UNITED STATES PATENT AND TRADEMARK OFFICE

APPLICATION NO.	FILING DATE	FIRST NAMED INVENTOR	ATTORNEY DOCKET NO.	CONFIRMATION NO.
10/630,598	07/29/2003	Dominik J. Schmidt	015114-049120US	1638

Office Action Summary

DETAILED ACTION

FIG. 1

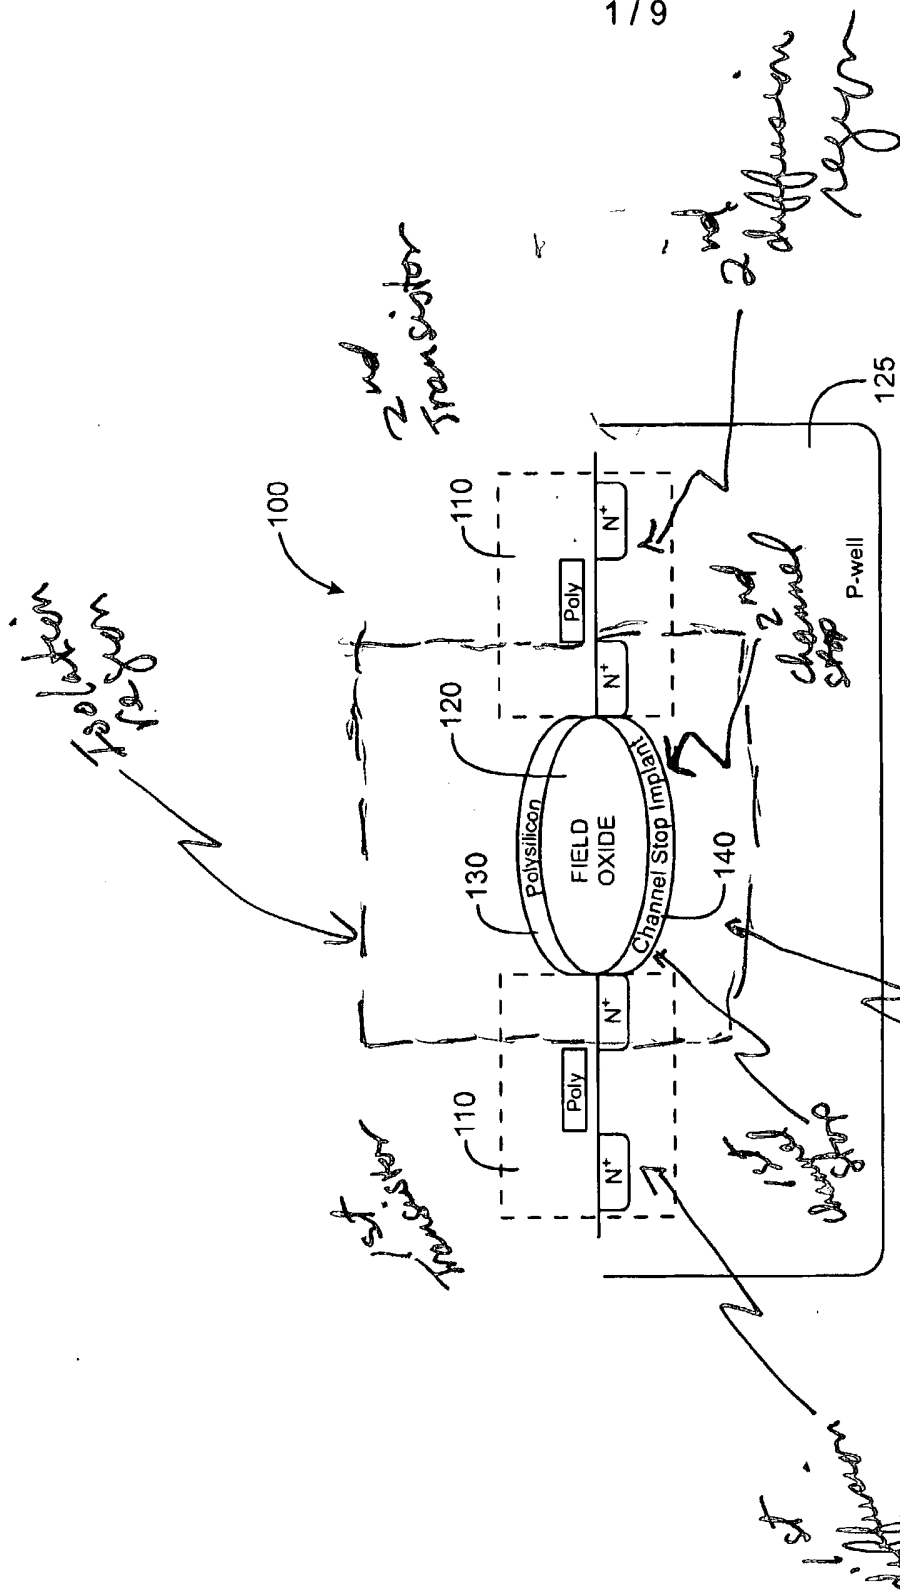
4. Claims 1-5, 7-8, 15-17, 19-20 are rejected under 35 U.S.C. 102(a) as being anticipated by Admitted Prior Art (APA), fig. 1 and specification, pages 1-2.

APA teaches the method of making an IC having the steps of providing a first diffusion region with a source/drain region of a first transistor 110; providing a second diffusion region with a source/drain region of a second transistor 110; providing an isolation region between the first and second diffusion regions, and selectively implanting a first channel stop implant region 140 and a second channel stop implant region 140 in the isolation region, the first channel stop implant region separate from the second channel stop implant region, as claimed in claims 1 and 15. See fig. 1.

As to claims 2, 16, the first channel stop implant region and the second channel stop implant region define at least a portion of an isolation conductive path 130, 140 between the first diffusion region and the second diffusion region. See fig. 1.

As to claim 5, the method further comprising a third diffusion region, wherein the first channel stop implant region and the second channel stop implant region form at least a part of an isolation conductive path between the first diffusion regions the second diffusion region, and the third diffusion region. See fig. 1.

As to claims 7,19, the method further comprising providing a field oxide region 120 over the isolation region. See fig. 1.

As to claims 8, 20, the method further comprising providing a gate 130 over the field oxide region 120, wherein when a threshold voltage is applied to the gate, current flows in the isolation conductive path 130, 140. See fig. 1 and specification, page 2, lines 10-18.

APA discloses the invention substantially as claimed. However, APA does not explicitly teach that the IC may be an electro-static discharge protection device or a charge pump circuit. Nevertheless, it would have been obvious to one skilled in the art at the time the invention was made to construct the IC of APA and place the IC in an environment so as to use it as an electro-static discharge protection device or a charge pump circuit, since it is a prima facie obvious to an ordinary artisan attempting to maximize the different use of the IC device. See fig. 1.
